10.4 Other Features of Steam and Power Conversion

The information in this section of the reference ABWR DCD, including all subsections, tables, and figures is incorporated by reference with the following departures and supplements.

Figure 10.4-5 Condensate System

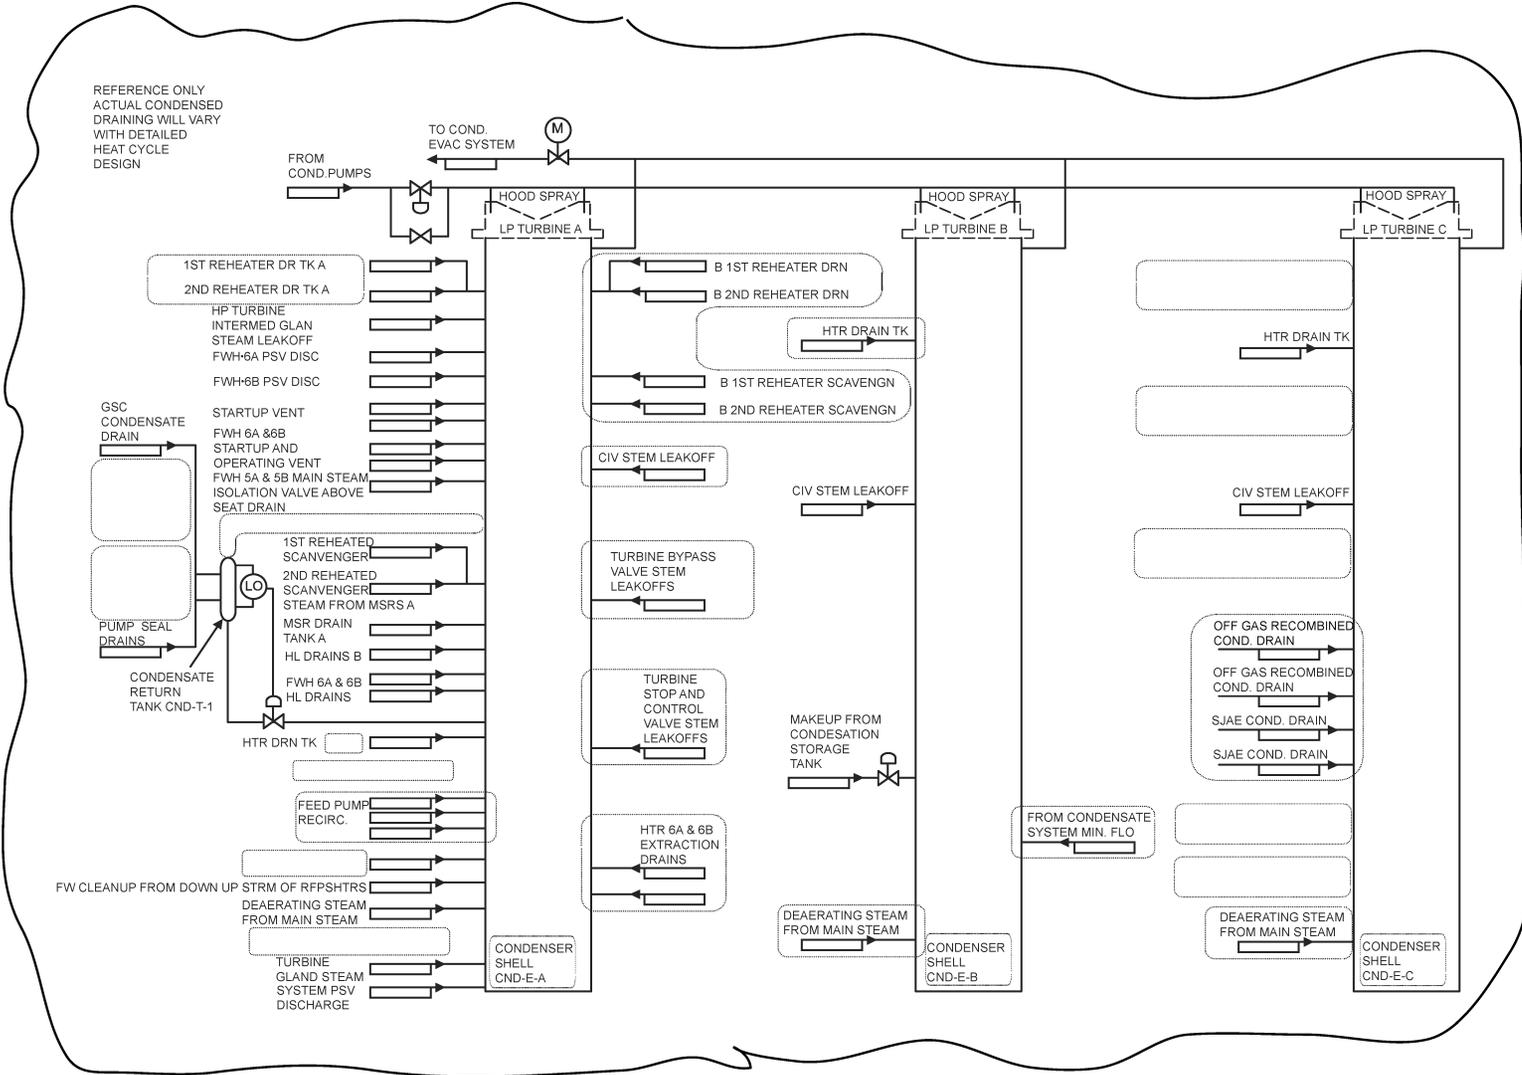
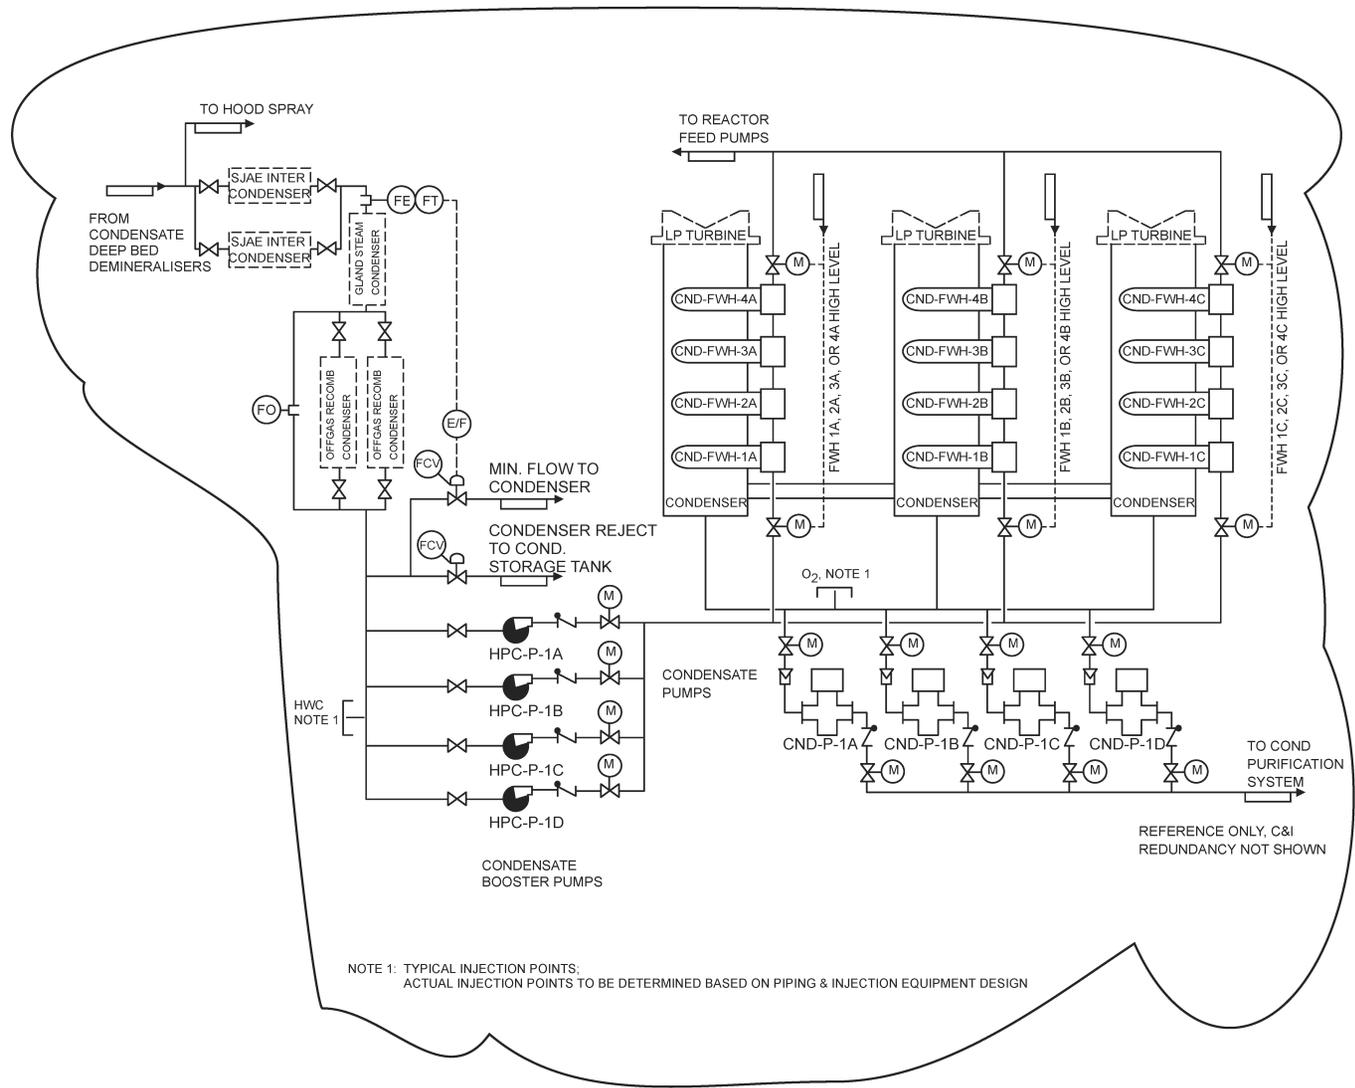
STP DEP 10.4-5

The CFS consists of four ~~33-50%~~ 33% capacity condensate pumps (three normally operating and one on automatic standby), four 33% capacity condensate booster pumps, (three normally operating and one on automatic standby), ~~three normally operated 33-65%~~ four 33% capacity reactor feedwater pumps (three normally operating, one on automatic standby), four stages of low-pressure feedwater heaters, and two stages of high- pressure feedwater heaters, piping, valves, and instrumentation. The condensate pumps take suction from the condenser hotwell and discharge the deaerated condensate into one common header which feeds the condensate filter/demineralizers.

Figure 10.4-6 Feedwater System

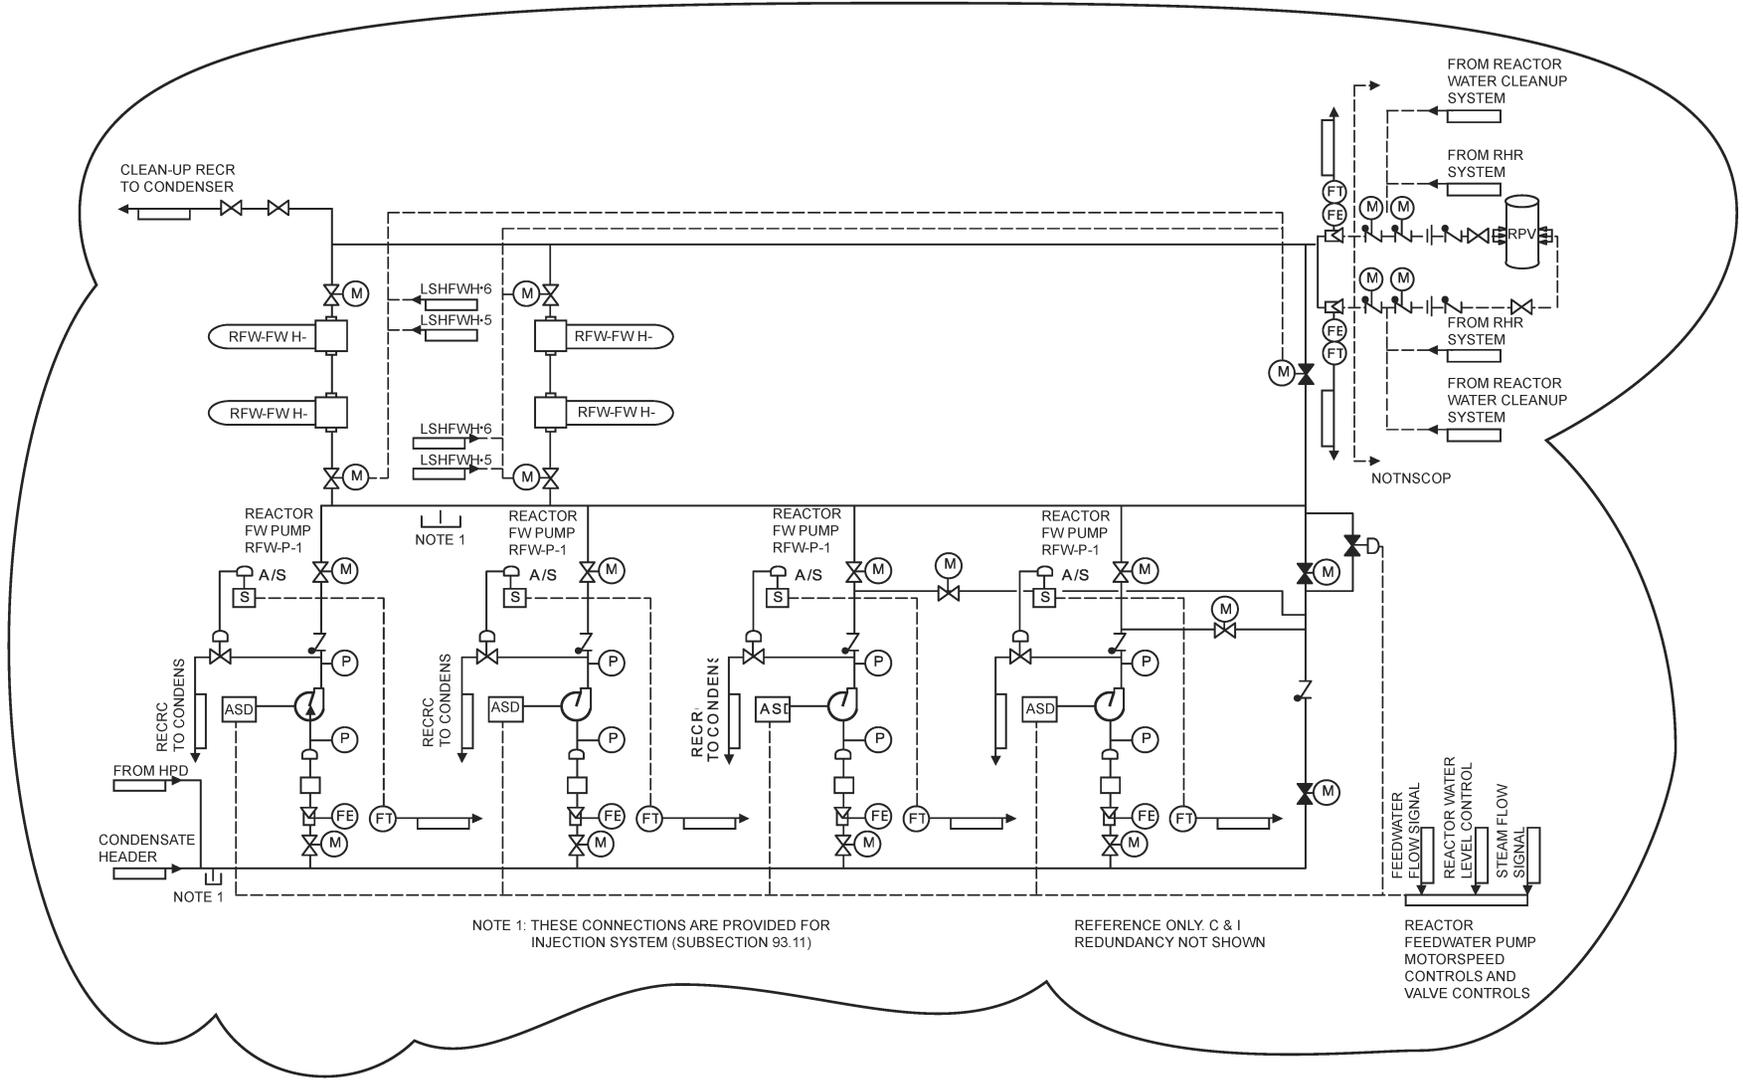
Downstream of the condensate demineralizers, the condensate is taken by a single header and flows ~~in parallel through five~~ through the auxiliary condenser/coolers, (one gland steam exhauster condenser, ~~and two sets of SJAE condensers~~, and two sets of offgas recombiner condenser (coolers)). The condensate then branches into three parallel strings of low pressure feedwater heaters. Each string contains four stages of low-pressure feedwater heaters. The strings join together at a common header which is routed to the suction of the reactor feedwater pumps.

Another bypass, ~~equipped with a feedwater flow control valve~~, is provided around the high-pressure heaters to ~~perform two independent functions~~. ~~During startup, the bypass and its flow control valve are used to regulate the flow of feedwater supplied by either the condensate pumps or the reactor feed pumps operating at their minimum fixed speed~~. ~~During power operation, the heater bypass function is to maintain full feedwater flow capability when a high-pressure heater string must be isolated for maintenance~~.

Reactor Feedwater Pumps—~~Three Four identical and independent 33-65% 33% capacity reactor feedwater pumps (RFP) are provided. The Three pumps normally manually operate in parallel and discharge to the high-pressure feedwater heaters. The pumps take suction downstream of the last stage low-pressure feedwater heaters and discharge through the high-pressure feedwater heaters. Each pump is driven by an adjustable speed drive.~~

Figure 10.4-9 Bypass Valve Control, Electro-Hydraulic Control Unit

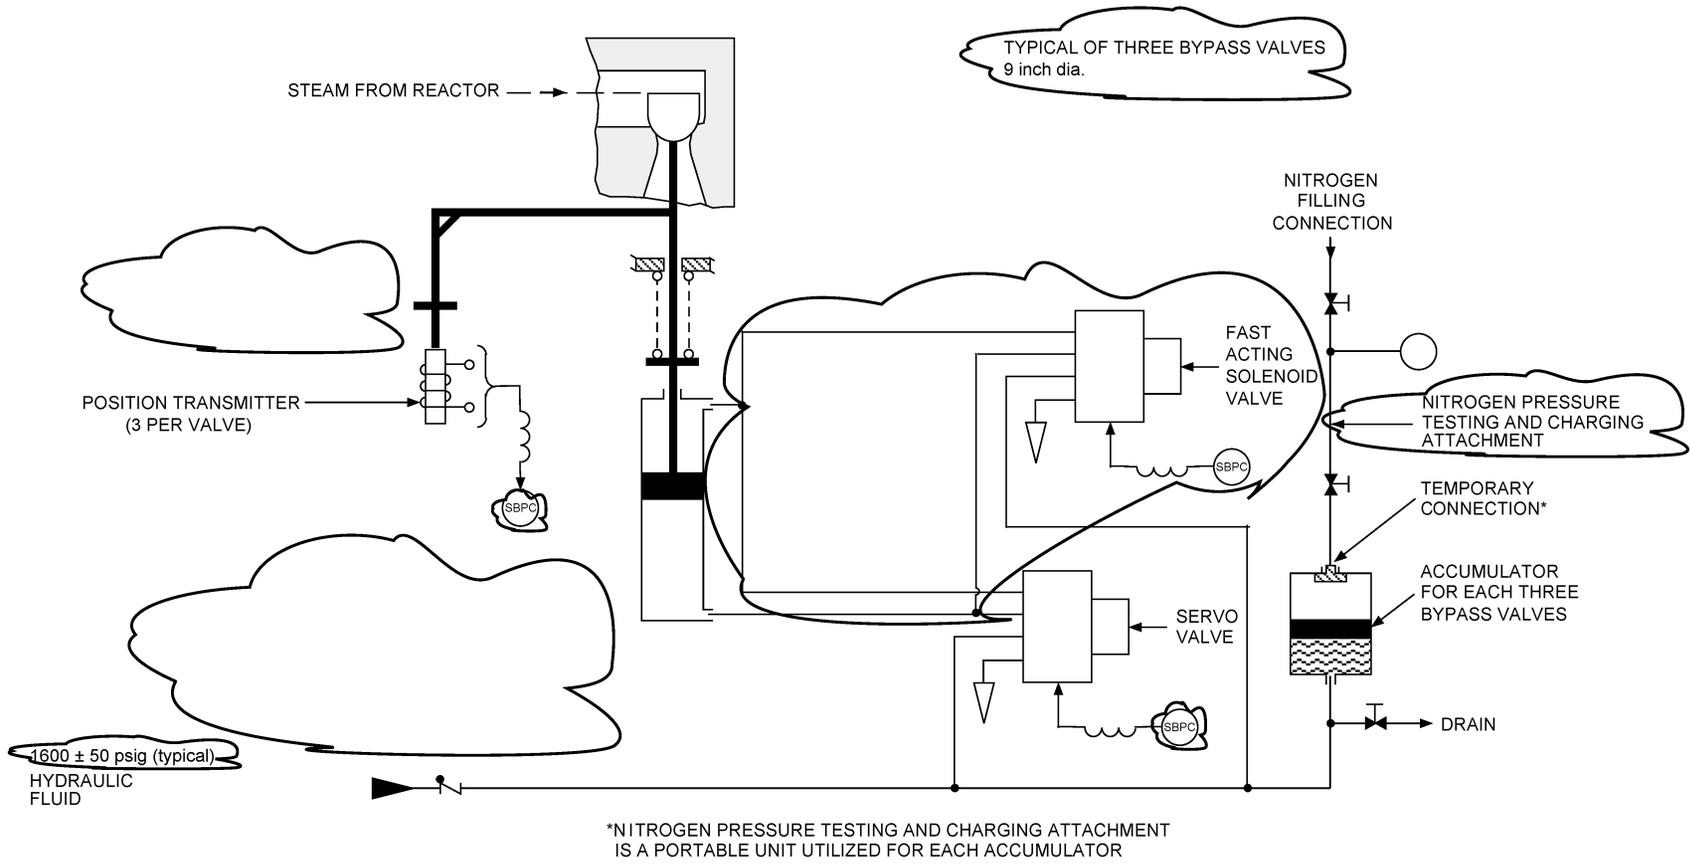
STD DEP 10.4-7 (Figure 10.4-9)
